Fairhope Planning Commission Agenda

July 6, 2026 – 5:00 PM

Fairhope Planning Commission Minutes

June 1, 2026 – 5:00 PM

UR 26.05 - 5 North Church Street

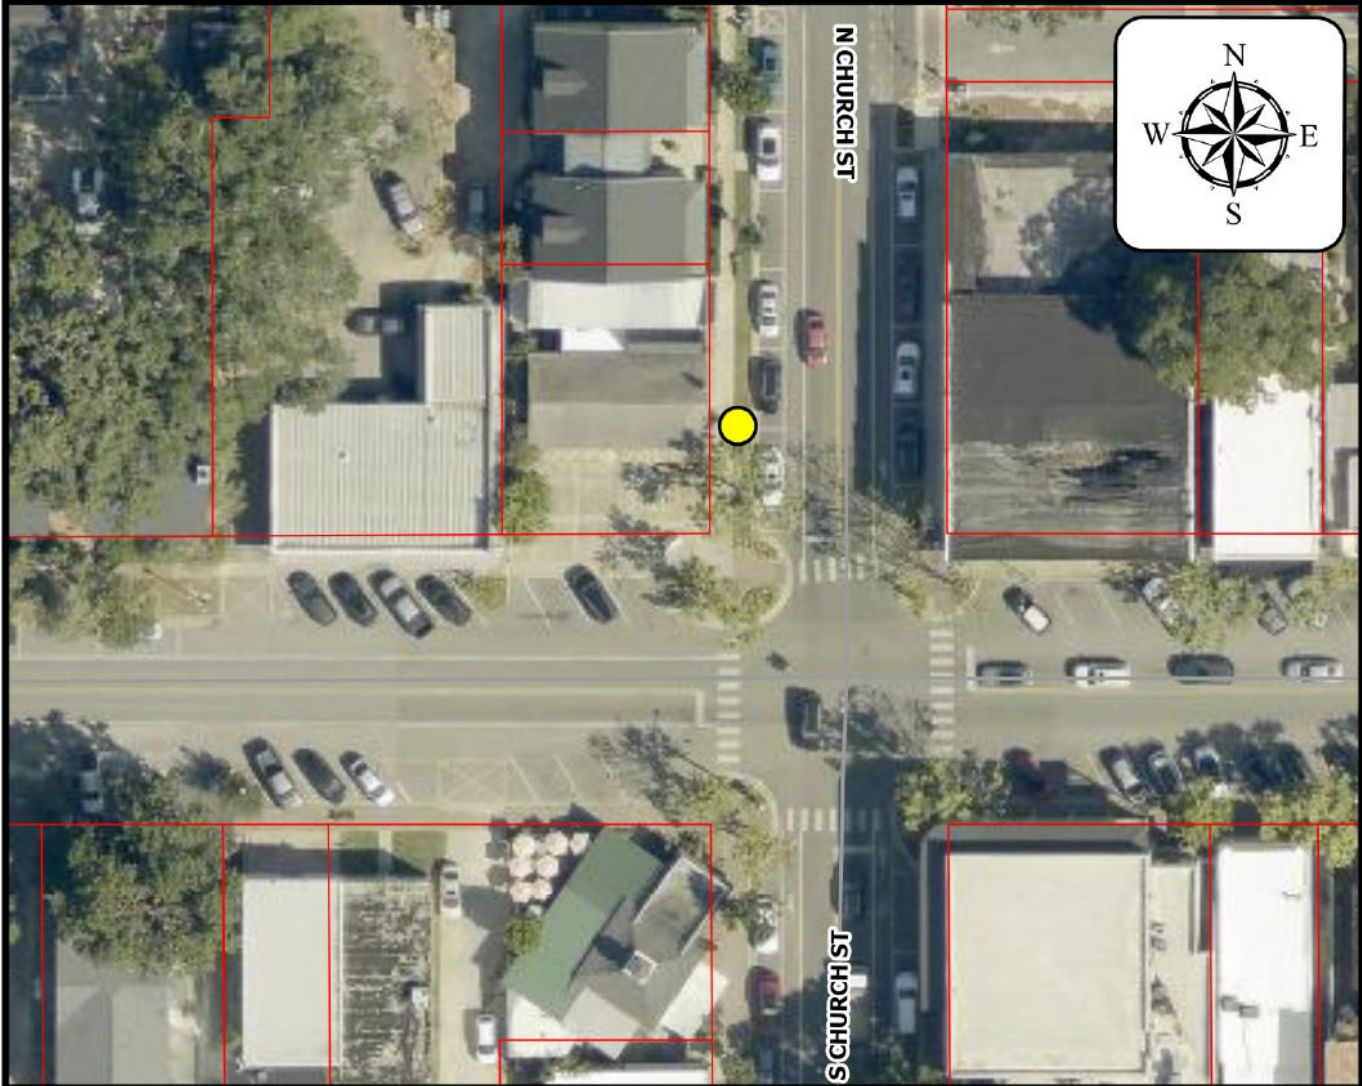
1. Install a street light arm on the pole as required by ROW and Utilities.
2. City Council approval of the proposed small cell.
3. A pre-construction meeting shall be held with the City prior to issuance of any permits;
4. Follow-up activities below required by staff and the applicant:
 - a. Upon satisfactory review and approval by ROW Construction Inspector, as-builts will be submitted to the GIS technician for inclusion in GIS utility maps;
5. Provide a Traffic Control Plan to ROW Inspector prior to commencement of any work.
6. Applicant shall contact Alabama One Call to locate all existing utilities (1000ft max per day).
7. Co-location shall be required if a viable option is determined.

UR 26.07 - 100 North Bancroft Street

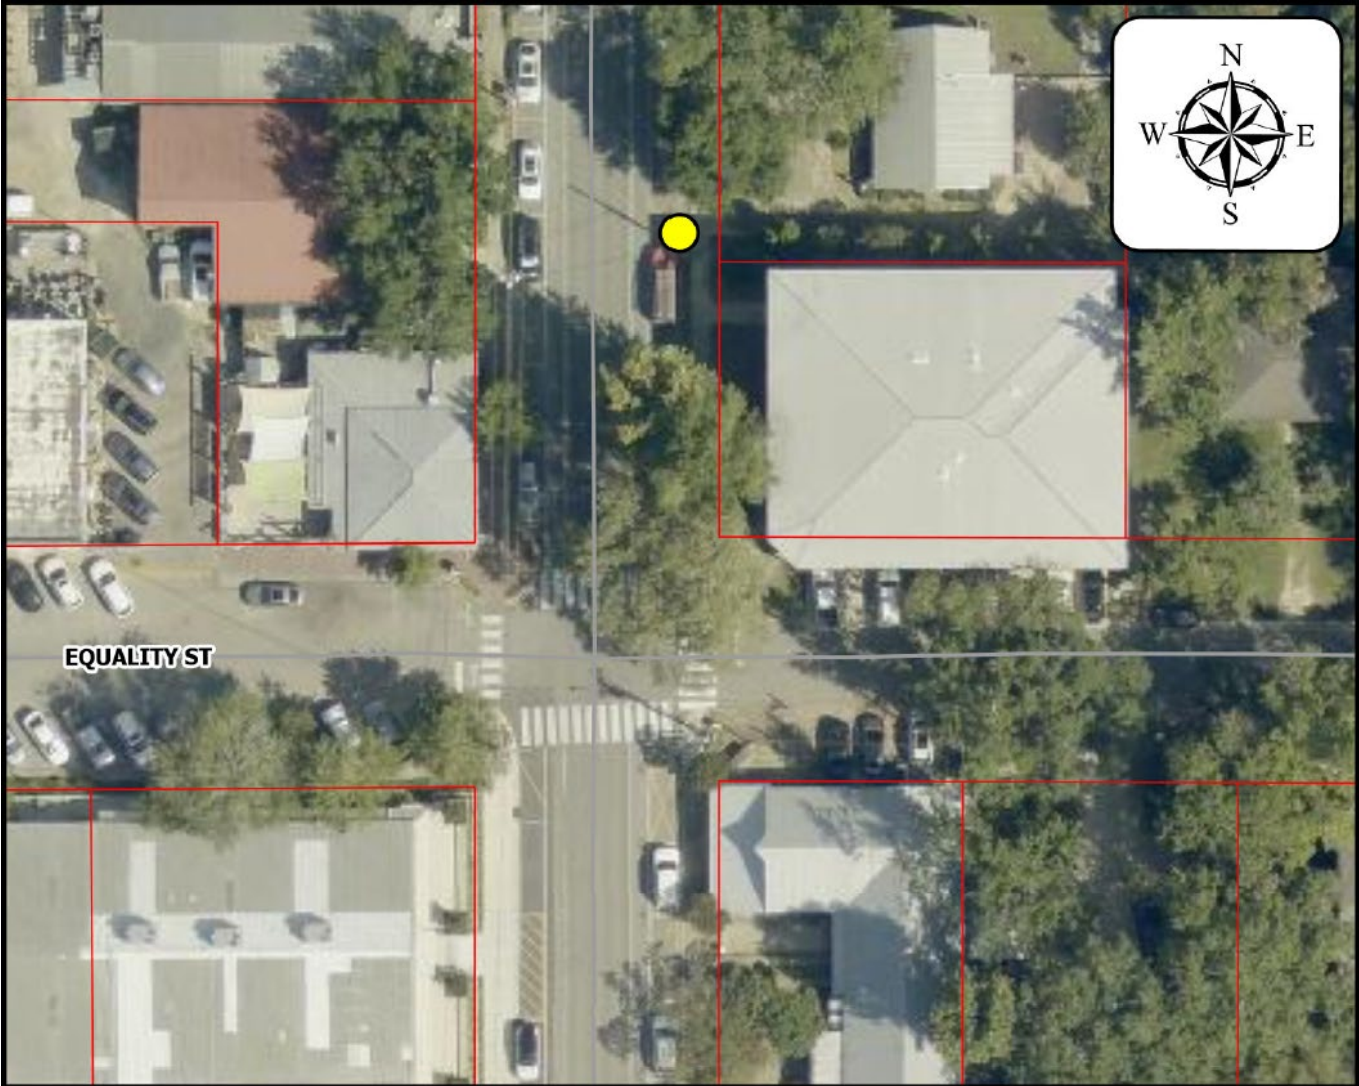
1. Install a street light arm on the pole as required by ROW and Utilities.
2. City Council approval of the proposed small cell.
3. A pre-construction meeting shall be held with the City prior to issuance of any permits;
4. Follow-up activities below required by staff and the applicant:
 - a. Upon satisfactory review and approval by ROW Construction Inspector, as-builts will be submitted to the GIS technician for inclusion in GIS utility maps;
5. Provide a Traffic Control Plan to ROW Inspector prior to commencement of any work.
6. Applicant shall contact Alabama One Call to locate all existing utilities (1000ft max per day).
7. Co-location shall be required if a viable option is determined.

LANDSCAPE PLAN

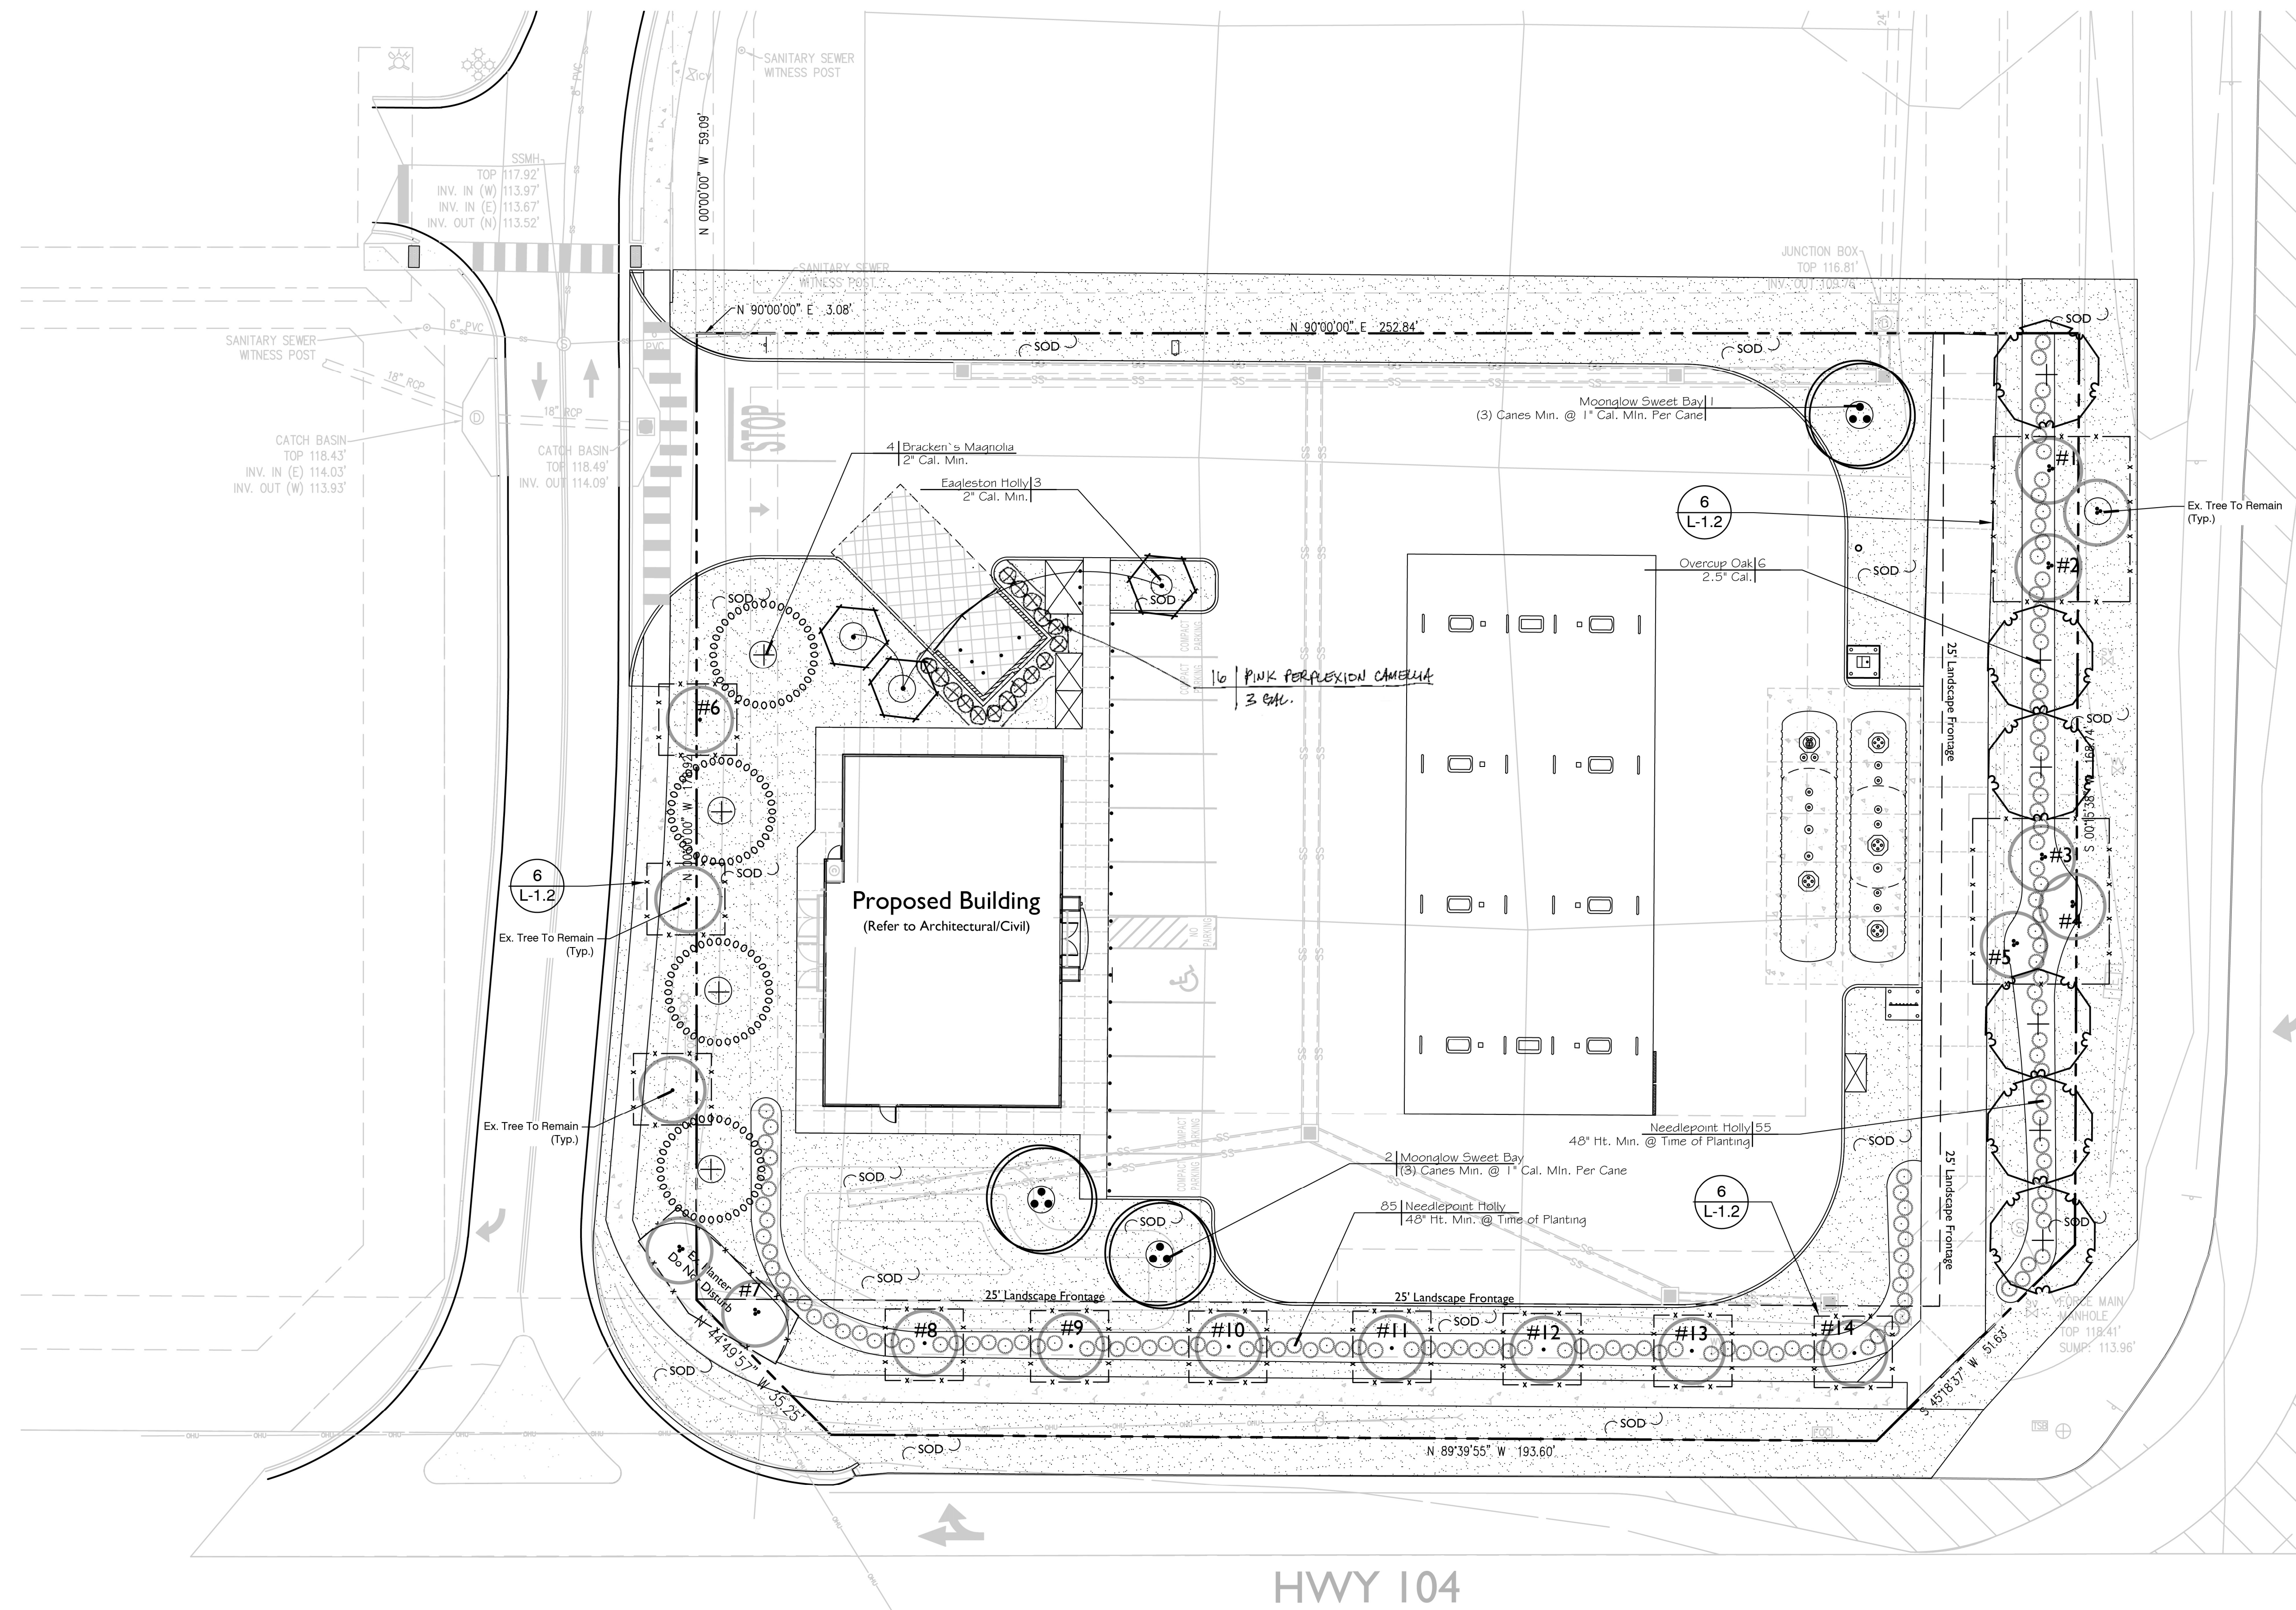
Additionally, the tree plan illustrates six (6) crape myrtle trees along State Highway 181. It's important to note that these six (6) understory trees are existing and were included in the original landscape plan approved with the Planter's Pointe Multiple Occupancy Project (MOP), and as such, cannot be removed and must be protected throughout construction. However, one of the existing crape myrtles appears to be located within

State ROW and should be either moved on site to be located on the other side of the two neighboring trees maintaining the intent of the original design OR the applicant may remove the existing tree altogether and plant a new crape myrtle of the same size and species as the one removed on site to be located on the other side of the two neighboring trees maintaining the intent of the original design.

1. Revision of the Tree and Landscape Plan to illustrate one of the following solutions to address the understory tree within State Highway 181 ROW:
 - a. Move the existing crape myrtle onto the subject site to be located on the other side of the two neighboring trees; or
 - b. Remove the existing tree and plant a new crape myrtle of the same size and species as the one removed on the subject site to be located on the other side of the two neighboring trees.
